SERVICE INFORMATION LETTER

Subject: Spur Gear ID too small causing difficult installation.

Service Information Letter No: 130514-001
 Page 1 of 3

Figure 1, Wencor Spur Gear Cross Section View

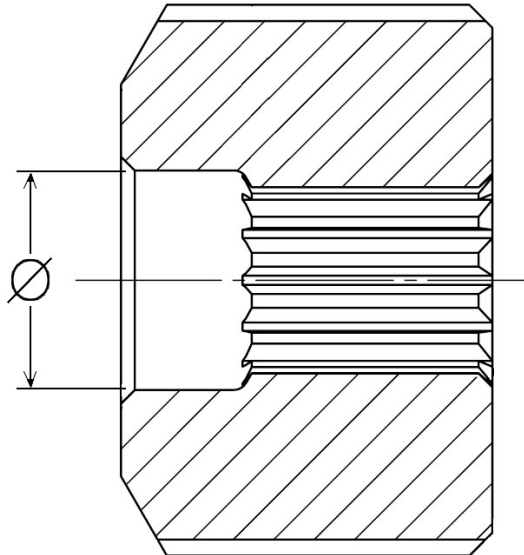
The Wencor Spur Gear was designed with an ID as shown below in Figure 1, which creates a tight fit onto the ATS Turbine Shaft during installation as shown in Figure 2.

The Wencor Spur Gear was designed for an interference fit (.0024 inches max) between the ID of the Spur Gear and the OD of the Turbine Shaft. Due to the small ID on the Wencor Spur Gear and depending upon the OD size of the Turbine Shaft, the installation may require the aid of press tooling or heating of the Spur Gear to fully assembly onto the Turbine Shaft. The component maintenance manual (CMM) does not call out any tooling or heating of the Spur Gear for this assembly process.

The Wencor Spur Gear has been redesigned with a slightly larger ID to create a transition fit, which matches the current design philosophy and allow assembly as described in the CMM.
